Modification of Conditions 2 & 6 of the final decision on Willow Ridge subdivision (SUB-20-01)

Willow Ridge

Modification of Conditions of Approval

SHEET:
4.0

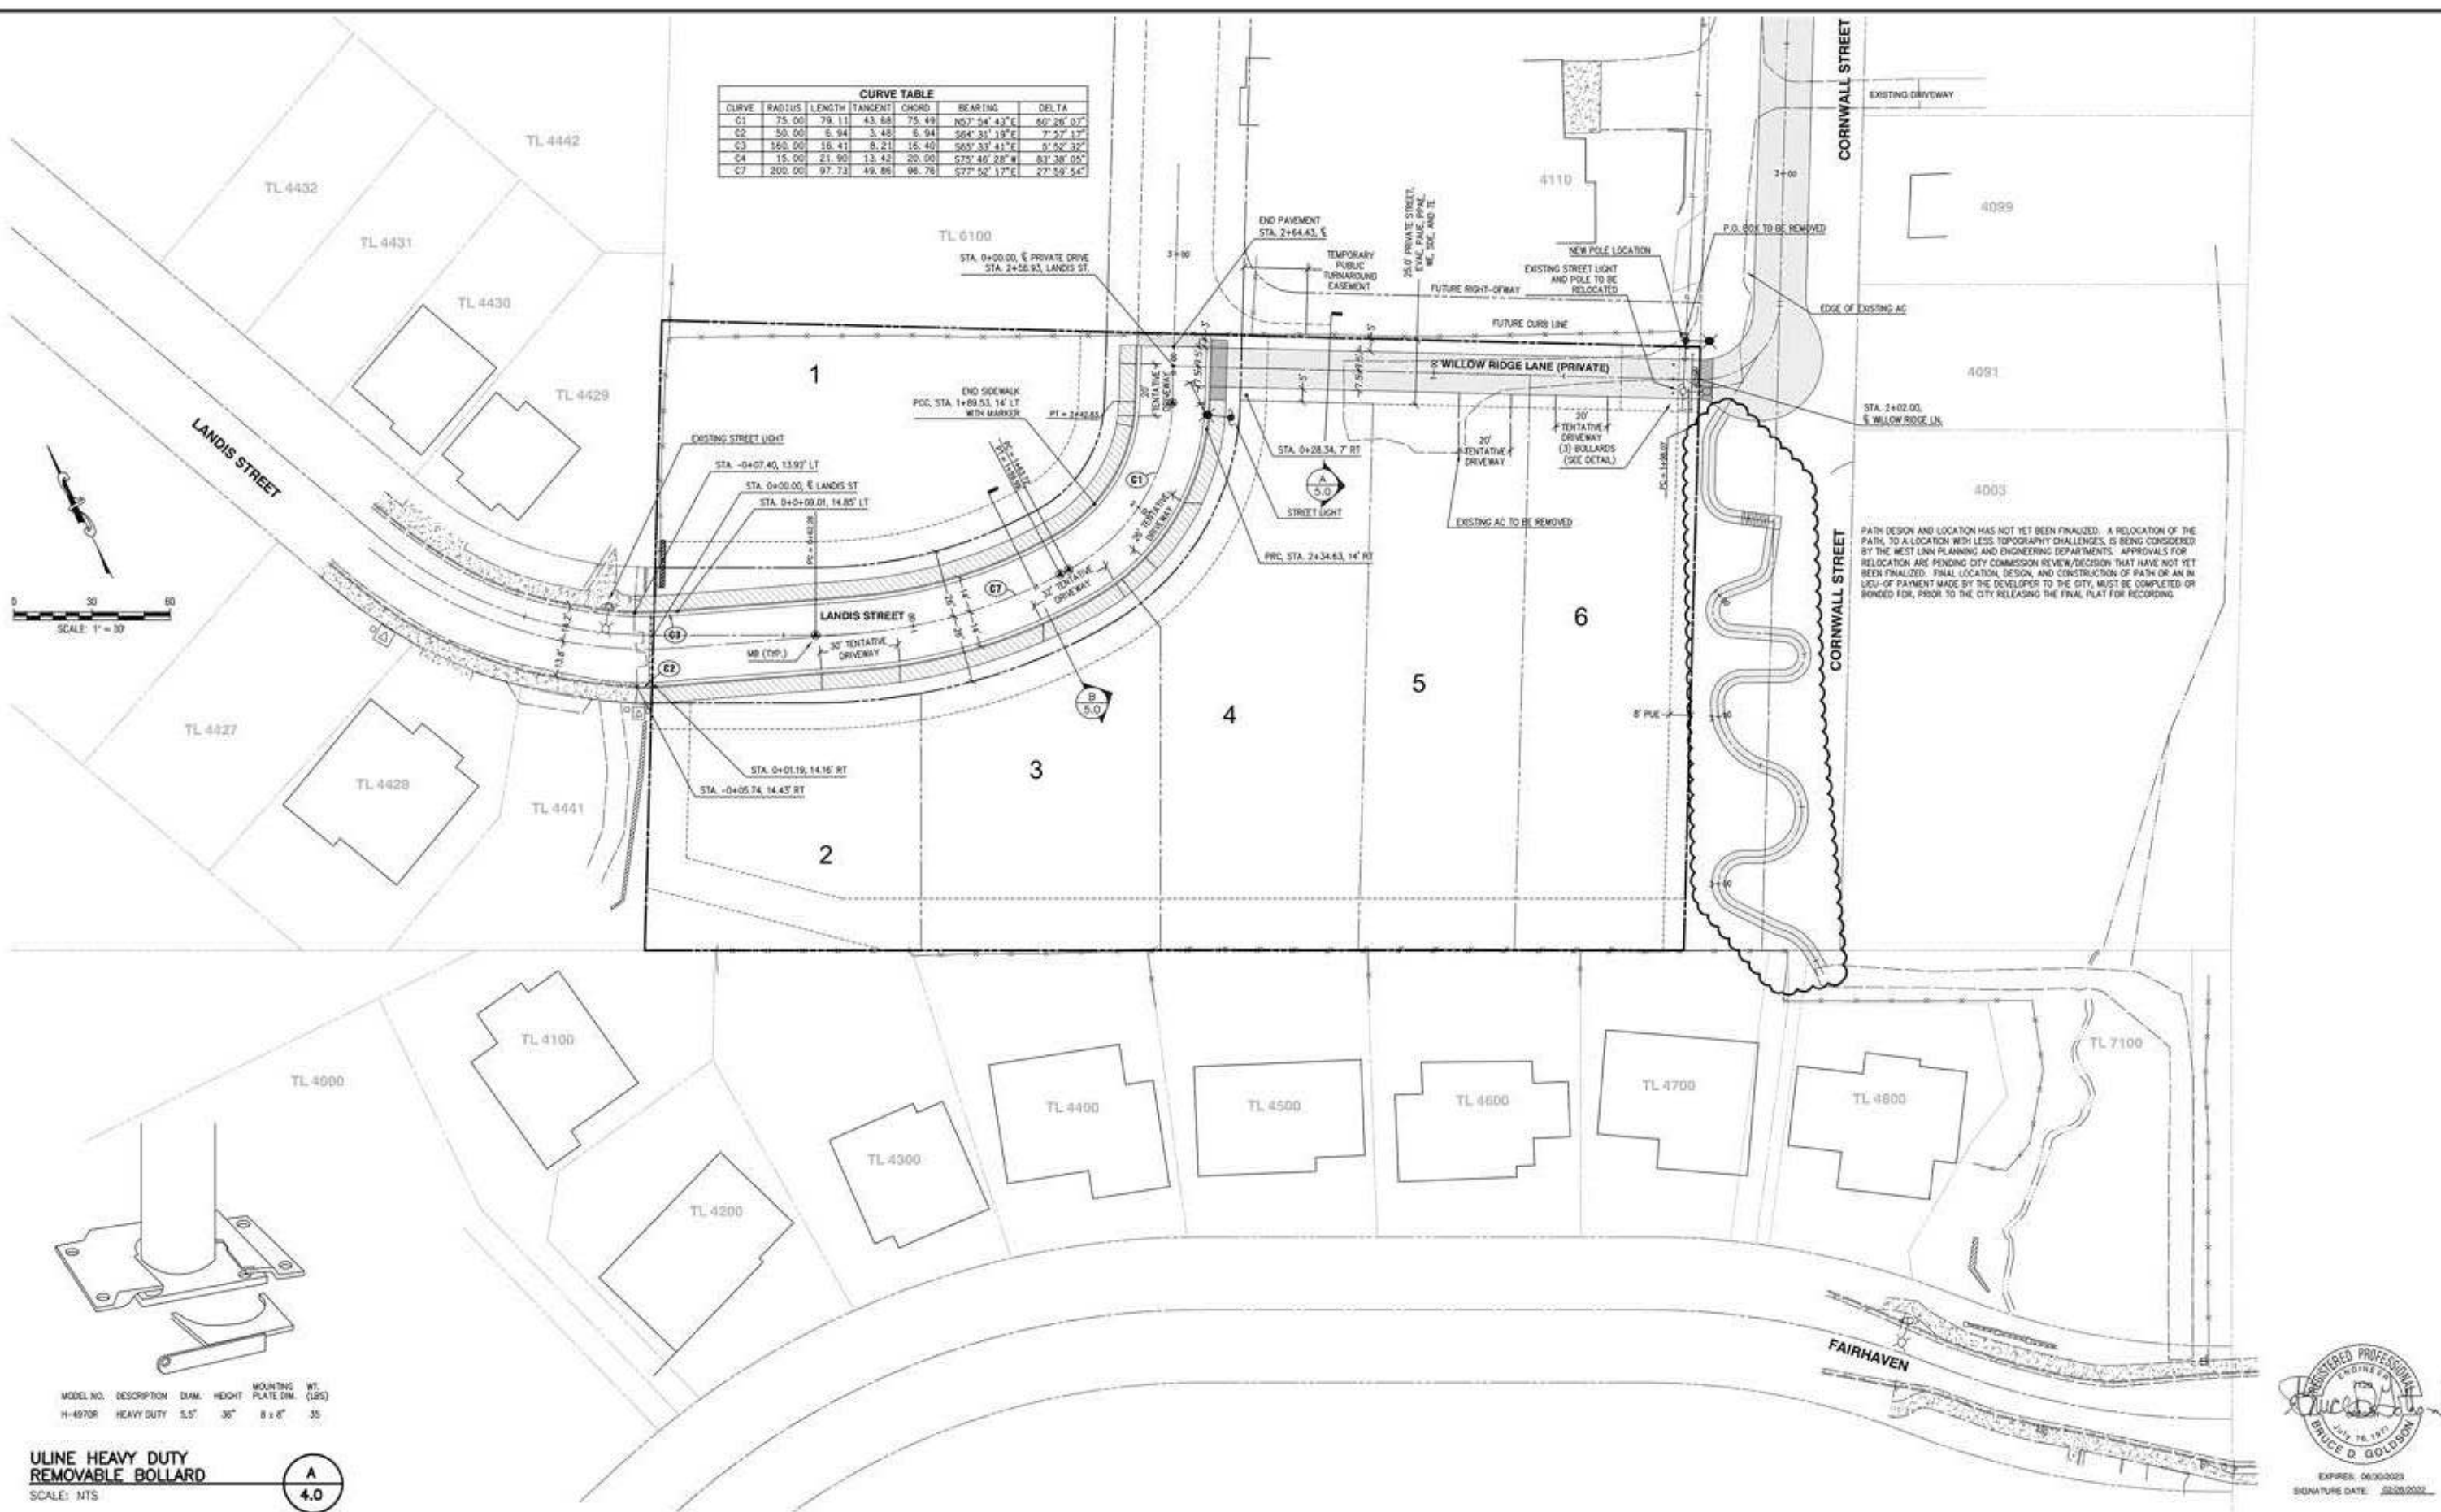
PATH DESIGN AND LOCATION HAS NOT YET BEEN FINALIZED. A RELOCATION OF THE PATH, TO A LOCATION WITH LESS TOPOGRAPHY CHALLENGES, IS BEING CONSIDERED BY THE WEST LINN PLANNING AND ENGINEERING DEPARTMENTS. APPROVALS FOR RELOCATION ARE PENDING CITY COMMISSION REVIEW/DECISION THAT HAVE NOT YET BEEN FINALIZED. FINAL LOCATION, DESIGN, AND CONSTRUCTION OF PATH OR AN IN-LIEU-OF PAYMENT MADE BY THE DEVELOPER TO THE CITY, MUST BE COMPLETED OR BONDED FOR, PRIOR TO THE CITY RELEASING THE FINAL PLAT FOR RECORDING.
